SUBMISSION

a written submission by way of objection

RE: DA 2025/0923
92 NORTH STEYNE MANLY
WRITTEN SUBMISSION: LETTER OF OBJECTION
SUBMISSION: TULLOCH

PLAN SETOUT

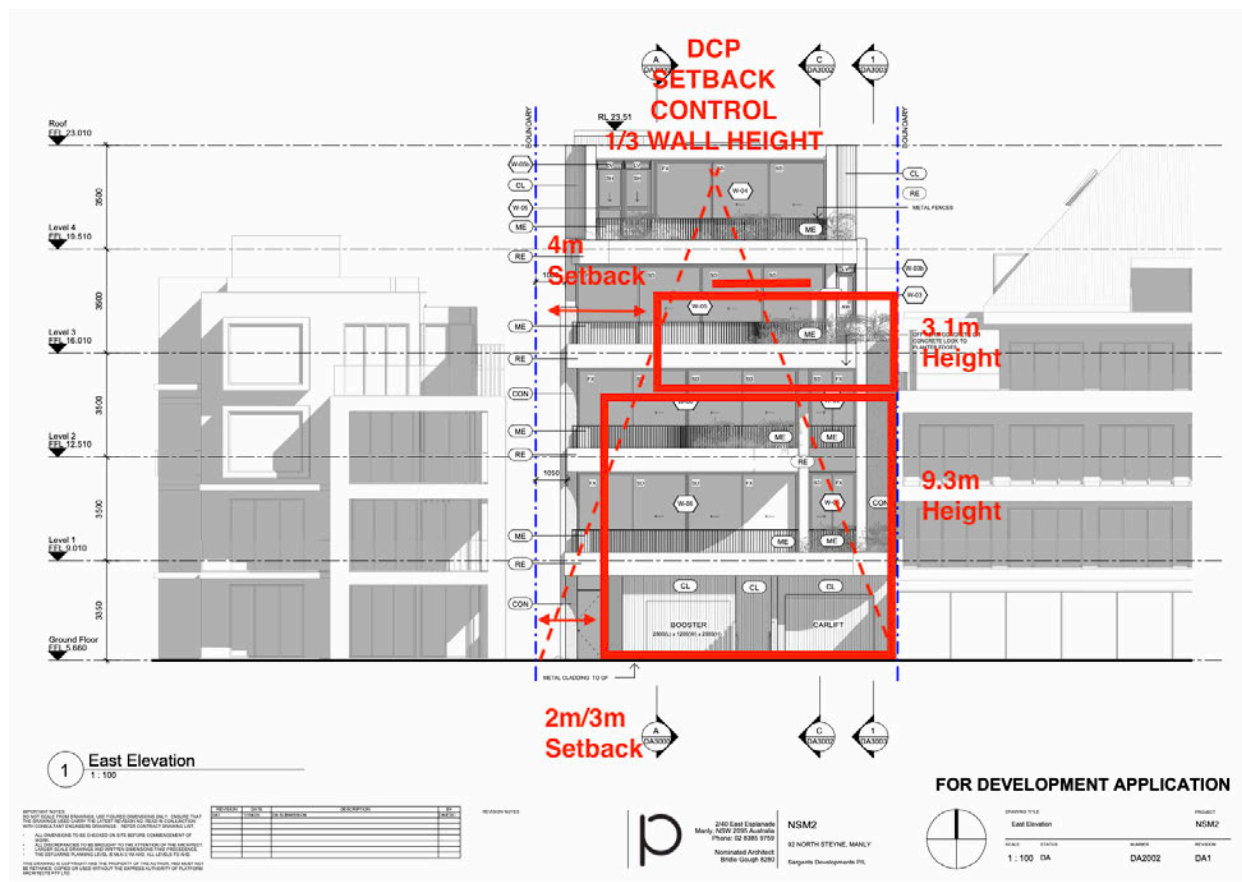
The marked-up Plan [in red], shows an envelope defined by:

- Front Setback: in full alignment with #91
- Rear Setback: 6m Rear Setback to accord with the SEPP;
- Southern Side Setbacks;
- Ground/First/Second: 2m, with additional setbacks at 3m to resolve solar access;
- Third Floor: 4m, with additional setbacks at 5m to resolve solar access;
- Roof: setback so as not to create any solar loss

EAST ELEVATION

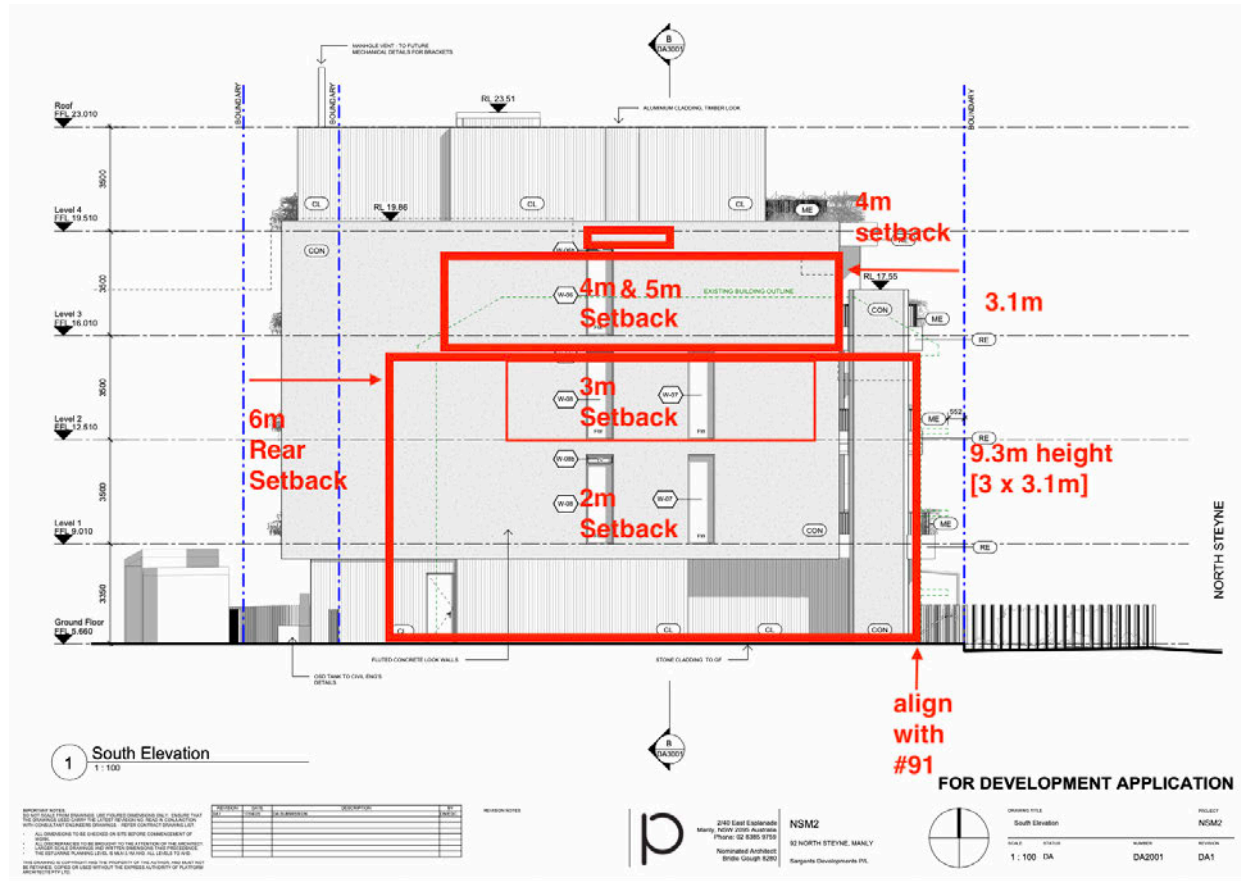
The marked-up Elevation [in red].

The dotted angles lines show the DCP Setback Control that defines a A-Frame type envelope that represents a complaint envelope to DCP controls.

The marked-up Elevation, shows an envelope defined by:

- 3.1m Storey Heights
- Front Setback: in full alignment with #91
- Southern Side Setbacks;
- Ground/First/Second: 2m, with additional setbacks at 3m to resolve solar access;
- Third Floor: 4m, with additional setbacks at 5m to resolve solar access;
- Roof: setback so as not to create any solar loss

The Applicant's Solar Diagrams:

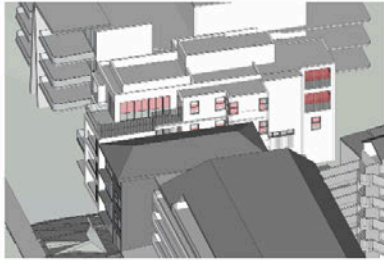
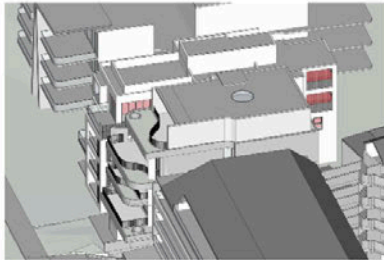
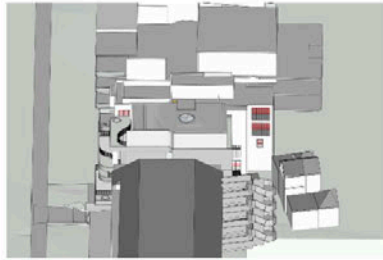
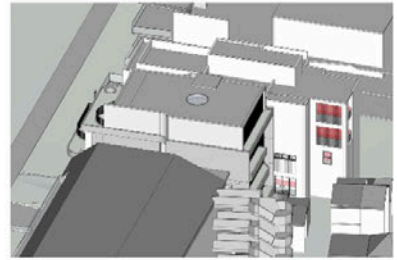
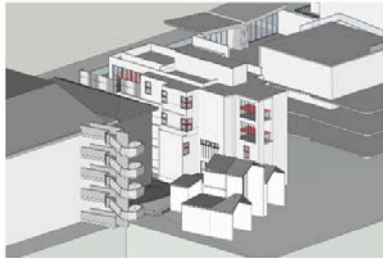
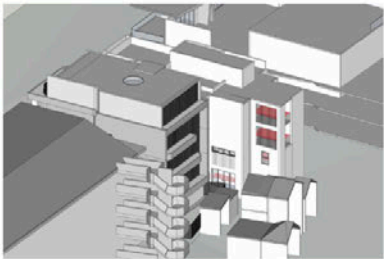
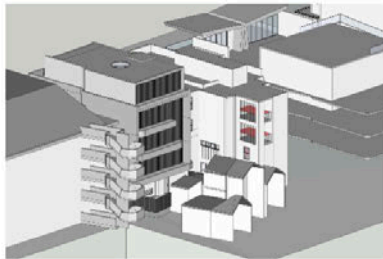
Shadow diagrams have not included the additional shadow cast by the non-complaint envelope, in plan and elevation. The elevational shadow diagrams must show the position of windows on adjoining properties.

The assessment of the development against the planning principle results in the development not complying with the solar access controls and therefore amended plans should be requested to reduce the overshadowing impact on the adjoining neighbour. It is suggested that a more skilful design of the development, with a compliant envelope control, would result in less impact in regard to solar access. It is requested that Council seek amended plans for the development to reduce the impact of the development, and these matters are addressed elsewhere in this Written Submission.

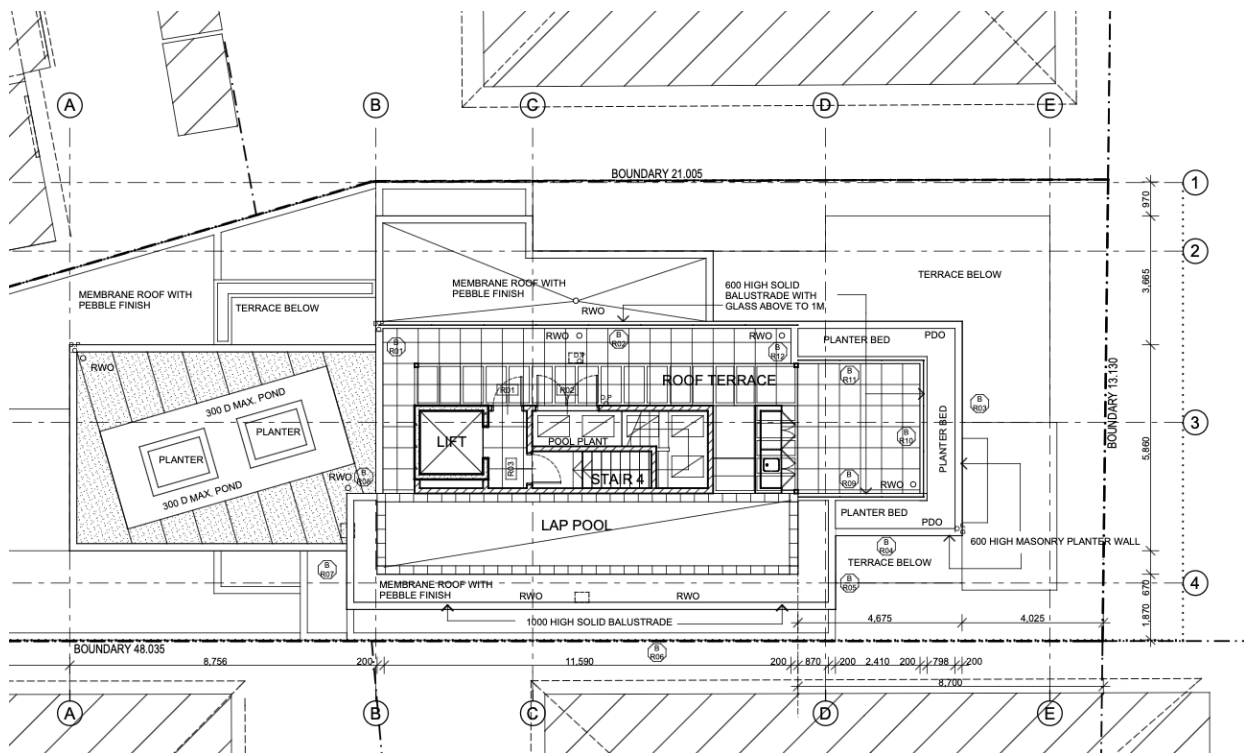
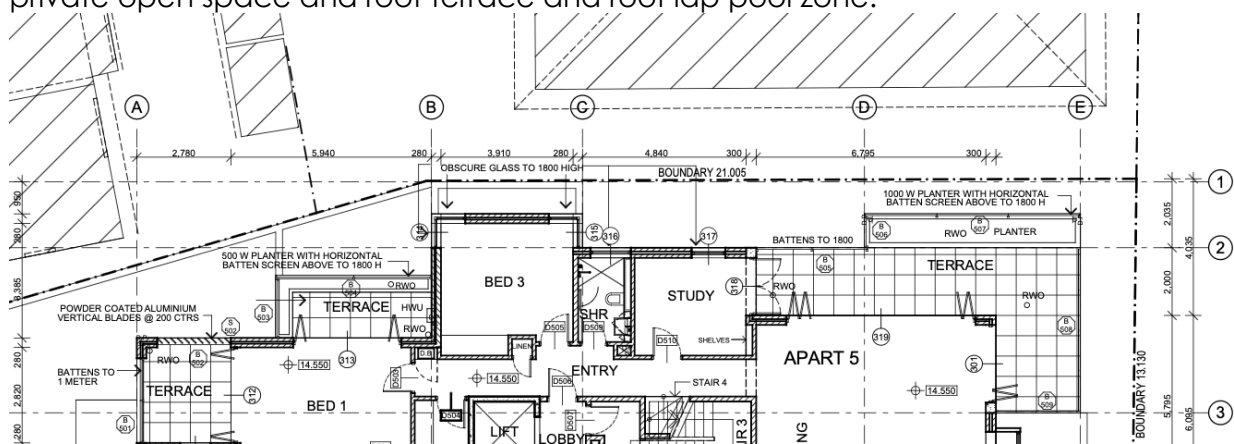
PHILLIP & DARRIANNE DONNELLY, UNIT 5/91 NORTH STEYNE MANLY
Devastating outcomes caused by non-compliant built form. Percentage loss not defined by the applicant, however substantial losses to all north facing windows, private open space and roof terrace and roof lap pool zone.

ANTHONY & ANNETTE FONTANA, UNIT 4/91 NORTH STEYNE MANLY

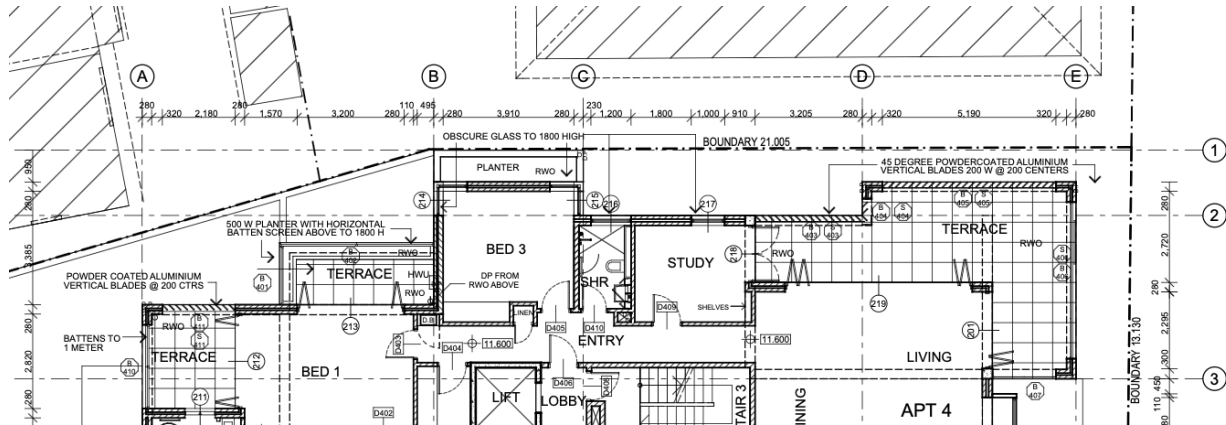
Devastating outcomes caused by non-compliant built form. Percentage loss not defined by the applicant, however substantial losses to all north facing windows, private open space.

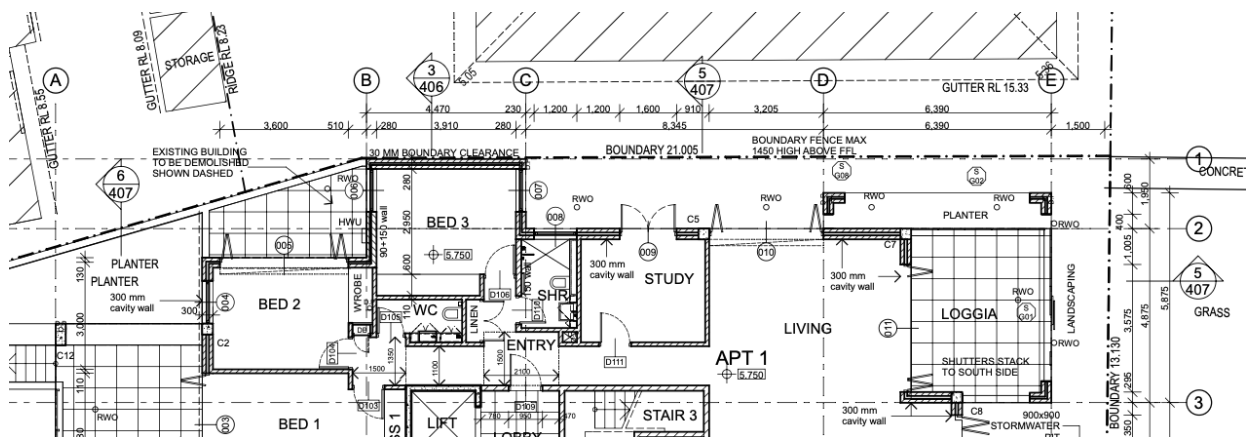
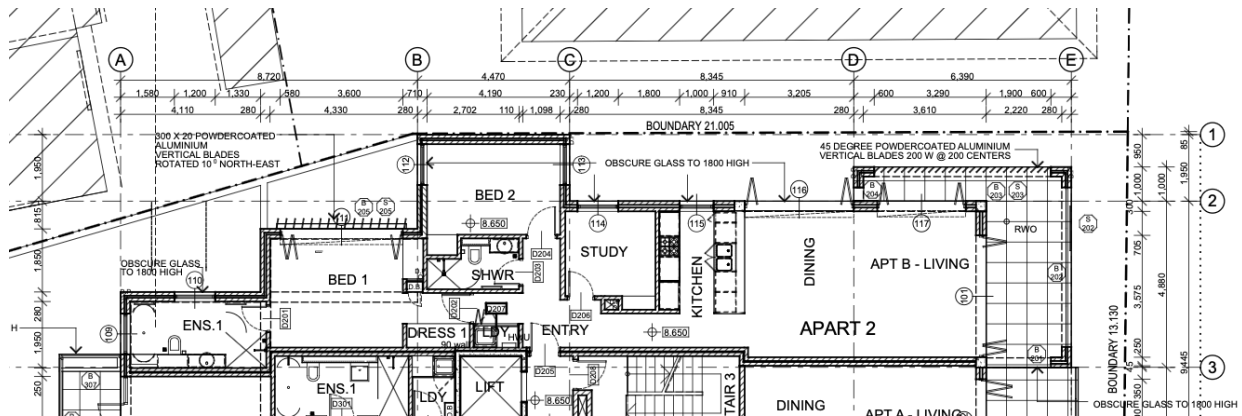
Devastating outcomes caused by non-compliant built form. Percentage loss not defined by the applicant.

All Owners request Winter and Equinox Diagrams at half-hour intervals to define the solar loss window-by-window, and full compliance to the DCP.
